PLANNING AND ZONING BOARD STAFF REPORT

Tiffany Cottages

Meeting	File No.	Application Type
April 21, 2025	2023-122-SPF-SPR-CL5	Level 2 Site Plan, including 2 variances & 1 landscape waiver
Property Owner	Authorized Agent	
Spanish River Road Apartments, LLC	Mike Covelli, Covelli Design Associates, Inc.

Efficiency Dwelling

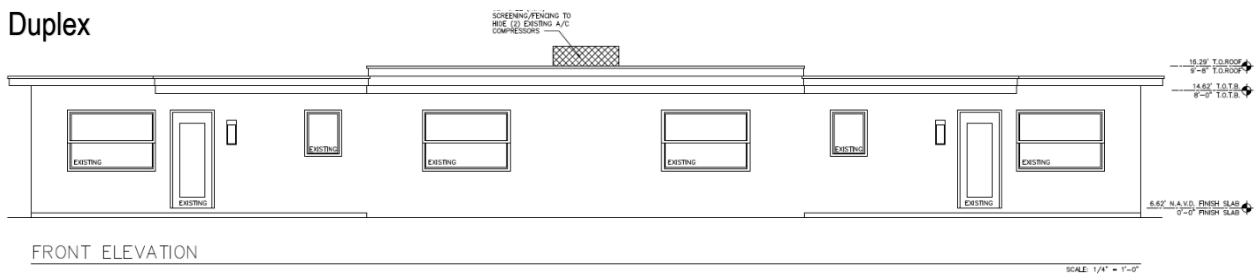
The architectural proposal combines a flat-roofed duplex and a pitched-roof detached unit, reflecting a blend of modern and traditional forms. While the roof variation introduces some contrast, the overall design remains relatively modest and is consistent with the form and features of duplexes common to its era of construction. The duplex elevation incorporates a central stone element that adds a subtle architectural detail that compliments the simplicity of the architecture. The stucco finish and neutral color scheme are compatible with nearby development and help maintain visual consistency across the site and rooftop screening has been applied to conceal mechanical equipment from the right-of-way.

The efficiency unit is set to the rear and presents a simpler expression, which reduces its visual prominence. Windows and doors are positioned to support natural lighting and privacy, Landscaping around the structures contributes to softening the site and supports the integration of built form and open space. The elevations demonstrate functional adequacy but limited visual innovation. While the design

of the detached efficiency unit meets the baseline requirements of Section 4.6.18, opportunities remain to enhance architectural detailing such as shutters, lighting, siding or bold colors.

Review & Analysis: Landscape Plan

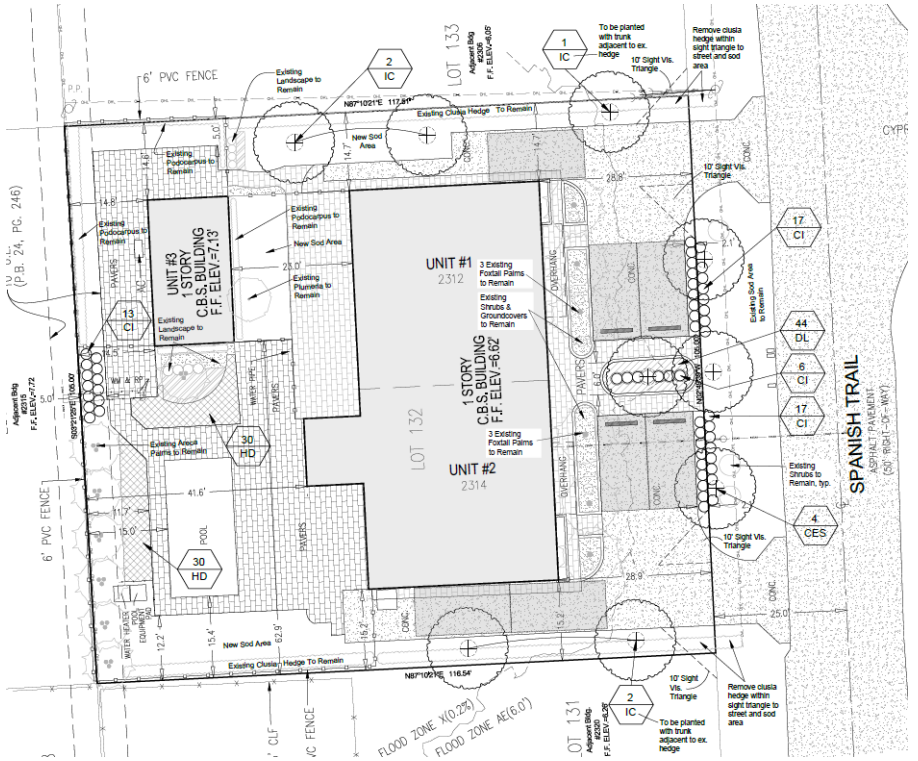
The proposed landscape plan responds to the intensified use of the property by incorporating elements required for multifamily residential development. The plan includes a combination of canopy trees, hedges, and foundation plantings intended to meet minimum standards while enhancing site functionality.

A circular driveway accommodating two parking spaces on each side facing each other creating a total of four parking spaces. A Green Buttonwood tree is located within a 6-foot landscape strip between parking spaces. This not only divides the parking area as required per the landscape code, adding more greenery but also provides organization. In addition, three Green Buttonwood trees are placed along the front of the property along Spanish Trail. The proposed trees are well suited for urban landscapes, providing shade, reducing heat, and improving air quality. Their placement in the front enhances curb appeal and creates a welcoming environment.

The north and south boundary is lined with hedges providing privacy and a natural barrier, enhancing the visual appeal and delineating the property. Both boundaries' features Dahoon Holly trees and hedges. Dahoon Hoolies are dense, evergreen trees ideal for creating privacy and adding vertical interest.

Overall, the landscape plan has been deemed technically compliant with the applicable requirements of LDR Section 4.6.16, except where a waiver is requested.

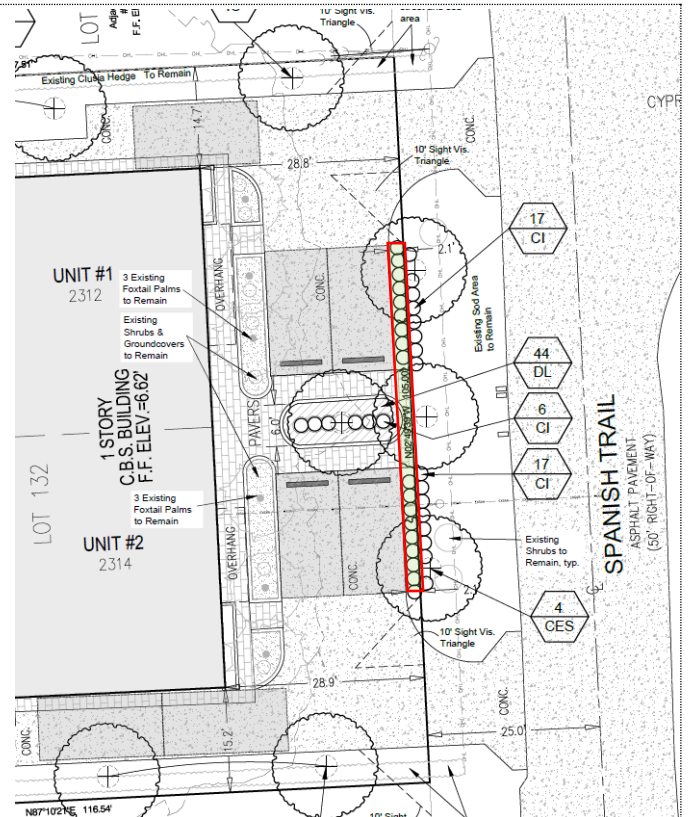
The reviewing body must review and make a recommendation on a waiver request based on a negative or positive finding on the above. The current parking layout is served by a circular driveway that allows vehicles to enter and exit without backing into the street. While this configuration avoids certain maneuvering concerns, the LDR still requires the landscape buffer because back-out parking is not utilized. The site is legally nonconforming to this standard and, as part of the redevelopment, is required to come into compliance.

To mitigate the reduced buffer, the applicant proposes shifting the existing driveway to create a 2.1-foot-wide landscaped strip along the frontage. While this does not fully meet the five-foot requirement, the plan incorporates Green Buttonwood trees and foundation plantings intended to soften the frontage, enhance visual interest, and provide partial screening of the parking area. The inclusion of three Green Buttonwood trees along Spanish Trail, combined with perimeter hedges and existing palms, is intended to offset the reduced width by enhancing vertical landscape elements and curb appeal.

Staff notes that additional space exists between the building façade and the current plantings, which could allow for greater compliance. However, the applicant has indicated that further removal of hardscape would conflict with established foundation landscaping and pedestrian pathways.

While the landscape buffer does not fully satisfy the dimensional LDR requirement, the proposed landscape improvements appear to reduce visual impacts and maintain compatibility with the surrounding streetscape. The effectiveness of this mitigation will depend on planting density, maturity, and long-term maintenance. The applicant has indicated a willingness to enter into a landscape maintenance agreement for the portion of landscaping encroaching into the public right-of-way, which may further support the waiver request.
